Access Compliance Report

Public Rights-of-Way

(Curb Ramps)

Intersection ID: 15955	Main Street: IDLEWILD_RD	Cross Street: ROSEHILL_DR	Location: NE
ADA ID: FF328F4689EC	Ramp Type: PerpDiag	Initial Pass/Fail: Fail	Overall Compliance: No
Severity Score: 25			
Codes/Mitigation Info/Possible Solution		Field Measurements/Component Compliance

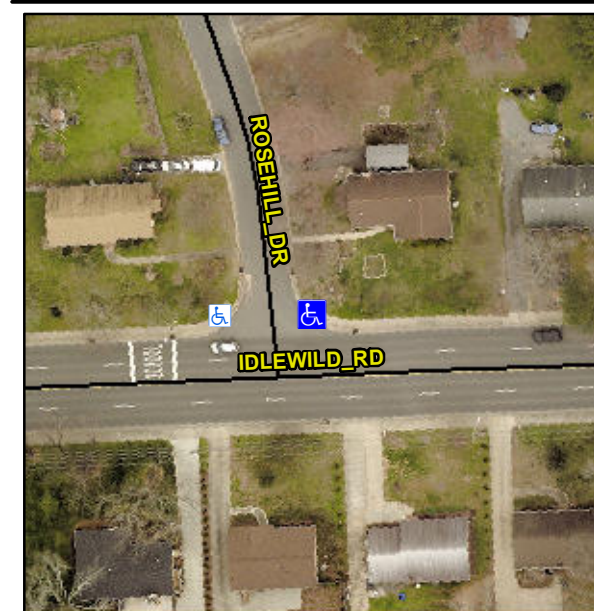
Not Found, R304.2.2

Compliance	Description	Data	Compliance	Description	Data
N/A	Ramp Length (in)	58.0	No	Ramp Slope (%)	12.1
Yes	Ramp Width (in)	48.0	Yes	Ramp XSlope (%)	0.7
N/A	Flare Type LT	N/A	N/A	Flare Type RT	N/A
N/A	Flare Slope LT (%)	N/A	N/A	Flare Slope RT (%)	N/A
N/A	Flare Traversable LT?	N/A	N/A	Flare Traversable RT?	N/A
N/A	Landing Length (in)	N/A	N/A	DWS Provided?	N/A
N/A	Landing Width (in)	N/A	N/A	DWS Contrast?	N/A
N/A	Landing Slope (%)	N/A	N/A	DWS Length (in)	N/A
N/A	Landing X Slope (%)	N/A	N/A	DWS Full Width?	N/A
N/A	Landing Curb? (Y/N)	N/A	N/A	DWS Offset (in)	N/A
N/A	Shared Landing?	N/A			
N/A	Gutter Ponding?	N/A	N/A	Gutter Slope (%)	N/A
N/A	Gutter Lip Ht (in)	N/A	N/A	Gutter X Slope (%)	N/A
N/A	Painted X Walk1?	Yes	N/A	Painted X Walk2?	No
	X Walk 1 Direction	To W		X Walk 2 Direction	To S
N/A	X Walk 1 Width (in)	108.0	N/A	X Walk 2 Width (in)	N/A
	X Walk 1 Slope (%)	2.7		X Walk 2 Slope (%)	1.3
	X Walk 1 X Slope (%)	0.9		X Walk 2 X Slope (%)	0.2

Remove & Replace Curb Ramp With Two New Directional Ramps or Equivalent.
